GENERAL ELECTRIC

POWER EQUIPMENT

TO: ALL ELEC-TRAK TRACTOR DEALERS

E8M/E10M ELEC-TRAK TRACTOR AUDIT

Figure 1A

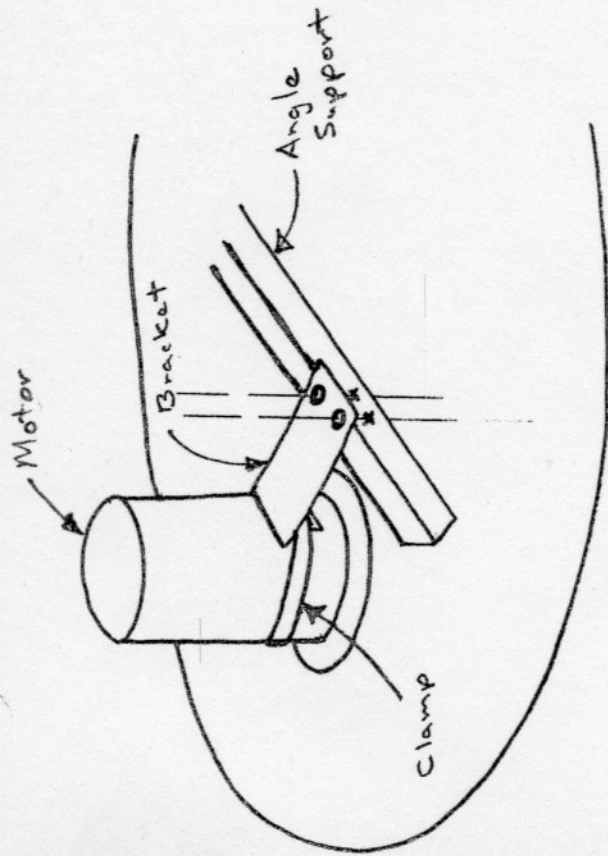
The mower motor modification effectively eliminates vibration and noise caused by any imbalance in the blades. The addition of a clamp and bracket to each motor effectively anchors the motors at a second point and minimizes any vibration that may occur. All mowers manufactured through June, 1972 should be modified as follows:

1. With the mower removed from the tractor, assemble one clamp around the motor near the base. Place a bracket as shown in the Figure 1A and secure with the clamp.

2. Using the bracket as a drill jig, drill 2 holes using a 0.28 (9/32) inch drill bit through the angle support of the mower. Use care to prevent marring the mower housing when the drill bit penetrates the angle support.

Figure 1B

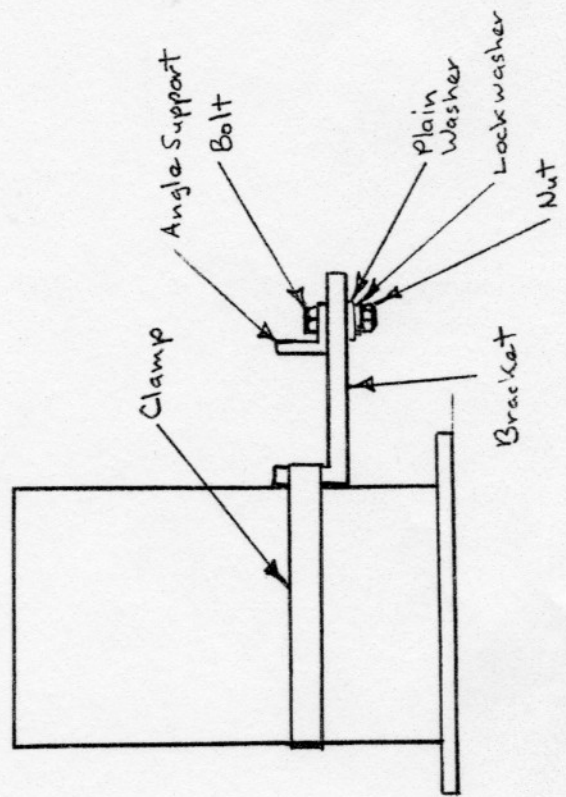
3. Repeat steps 1 and 2 for the other angle support.
4. Remove the brackets and install on the underside of each support so their tabs are flush with the motor and directed upwards as shown in Figure 1B. Secure with 1/4-20 x 3/4 inch bolts inserted from the top side with a plain washer, lockwasher and nut below each support. Finger tighten each nut.

5. Install a motor clamp around each motor so it engages its corresponding bracket tab. While holding the clamp parallel with the mower deck, tighten the clamp screw. Locate the screw toward the angle support to be inconspicuous when mower is assembled to tractor.

Figure 2

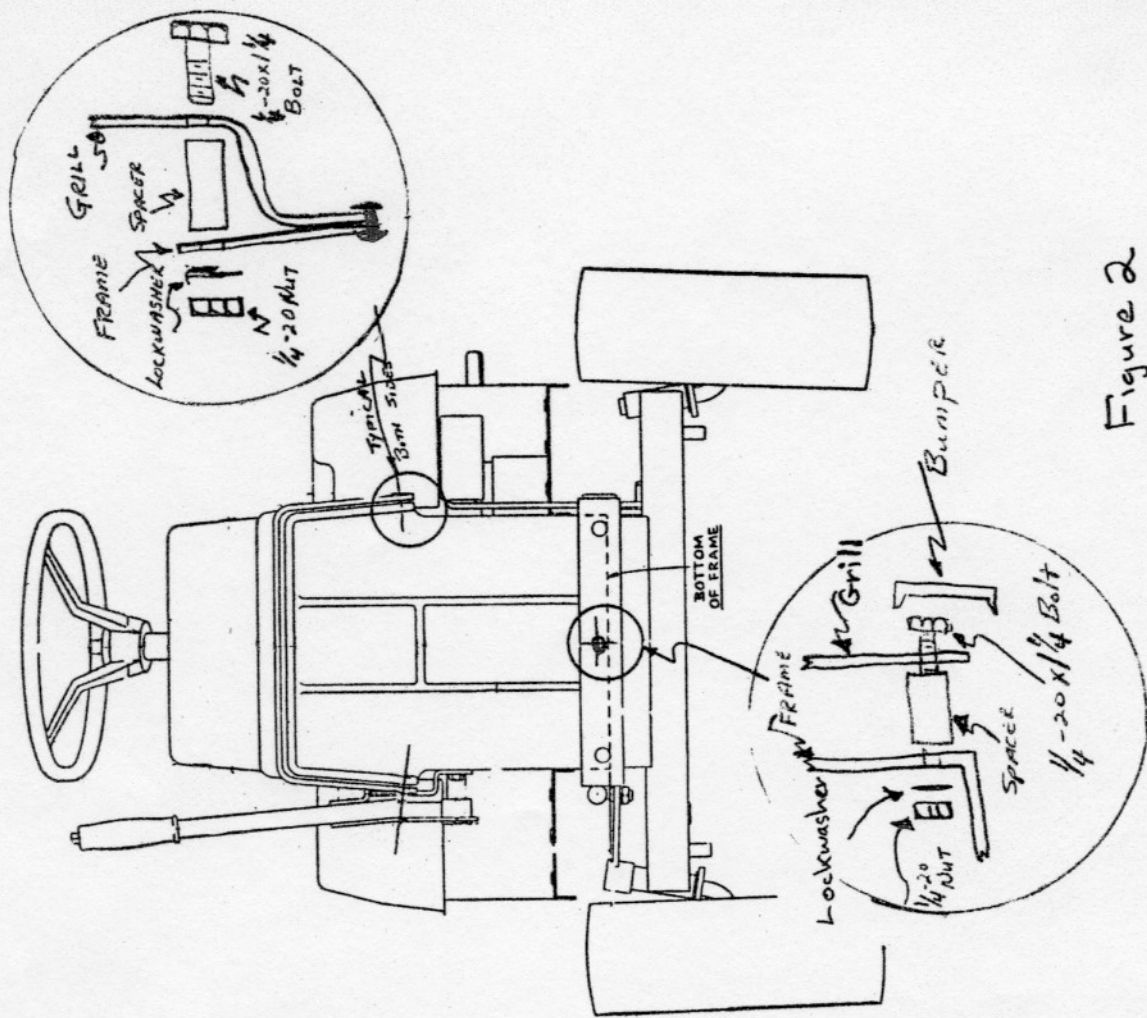
Three additional support points are to be added to the grills on all E8M and E10M Elec-Trak tractors manufactured through June, 1972 as follows:

1. Remove front battery and bumper.
2. Center punch the sides of the grill at a point as shown in Figure 2, so that subsequent drilling will allow the placement of a spacer between the grill and battery compartment as shown in Figure 2. Make sure the punch mark is located so the drilled hole will not tear through the edge of the grill or compartment wall.

3. Drill a 1/8 inch pilot hole at each punch mark and then drill a 0.281 (9/32) inch hole at each pilot hole making sure the drill bit passes through the battery compartment perpendicularly. See Figure 2 insert.

4. Force a spacer between the holes in the grill and compartment wall and secure with a 1/4-20 x 1 1/4 inch bolt, lockwasher and nut with the bolt head on the outside of the grill. Repeat for other side.

5. Center punch a point in the center lower edge of the grill so subsequent drilling will enter the front battery compartment as shown in the insert of Figure 2.
